Access Compliance Report

Public Rights-of-Way

(Curb Ramps)

Intersection ID: 50998	Main Street: S_TRYON_ST	Cross Street: STELECROFT_PY	Location: SW
ADA ID: DC958DF73F8E	Ramp Type: Perp	Initial Pass/Fail: Fail	Overall Compliance: No
			Severity Score: 13.75

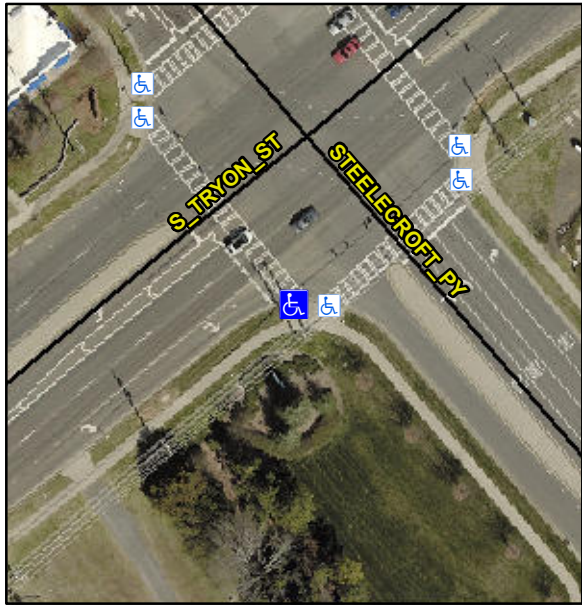
Codes/Mitigation Info/Possible Solution			Field Measurements/Component Compliance					
	Possible Solutions:		Compliance	Description	Data	Compliance	Description	Data
	Remove & Replace Entire Ramp.		N/A	Ramp Length (in)	95.0	No	Ramp Slope (%)	10.2
			Yes	Ramp Width (in)	48.0	No	Ramp XSlope (%)	2.5
			N/A	Flare Type LT	N/A	N/A	Flare Type RT	N/A
			N/A	Flare Slope LT (%)	N/A	N/A	Flare Slope RT (%)	N/A
			N/A	Flare Traversable LT?	N/A	N/A	Flare Traversable RT?	N/A
			N/A	Landing Length (in)	N/A	N/A	DWS Provided?	N/A
			N/A	Landing Width (in)	N/A	N/A	DWS Contrast?	N/A
			N/A	Landing Slope (%)	N/A	N/A	DWS Length (in)	N/A
			N/A	Landing X Slope (%)	N/A	N/A	DWS Full Width?	N/A
Surveyor Notes:			N/A	Landing Curb? (Y/N)	N/A	N/A	DWS Offset (in)	N/A
N/A			N/A	Shared Landing?	N/A			
PROW/ADA:			N/A	Gutter Ponding?	N/A	N/A	Gutter Slope (%)	N/A
R304.2.2, R304.5.3			N/A	Gutter Lip Ht (in)	N/A	N/A	Gutter X Slope (%)	N/A
